# Intel<sup>®</sup> Pentium<sup>®</sup> III Processor Specification Update

Release Date: August 2007

Document Number: 244453-058

The Pentium<sup>®</sup> III processor may contain design defects or errors known as errata which may cause the product to deviate from published specifications. Current characterized errata are documented in this Specification Update.

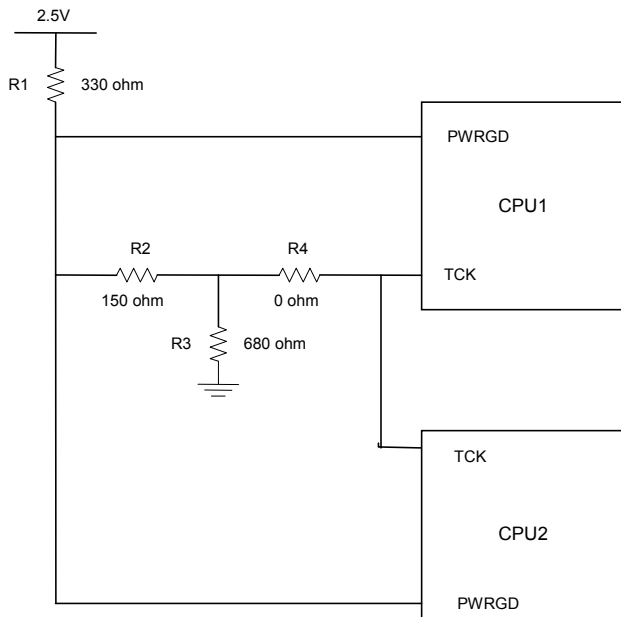
**Problem:** The internal control register bit responsible for operation of the Thermtrip circuit functionality may power up in a non-initialized state. As a result, THERMTRIP# may be incorrectly asserted during de-assertion of RESET# at nominal operating temperatures. When THERMTRIP# is asserted as a result of this erratum, the processor may shut down internally and stop execution but in few cases continue to execute.

**Implication:** This issue can lead to intermittent system power-on boot failures. The occurrence and repeatability of failures is system dependent, however all systems and processors are susceptible to failure. In addition, the processor may fail to stop execution during the event of a valid THERMTRIP# assertion resulting in the potential for permanent processor damage.

**Workaround:** To prevent the risk of power-on boot failures or catastrophic thermal failures, a platform workaround is required. The system must provide a rising edge on the TCK signal during the power-on sequence that meets all of the following requirements:

- Rising edge occurs after Vcc\_core is valid and stable
- Rising edge occurs before or at the de-assertion of RESET#
- Rising edge occurs after all Vref input signals are at valid voltage levels
- TCK input meets the Vih min and max spec as mentioned in EMTS
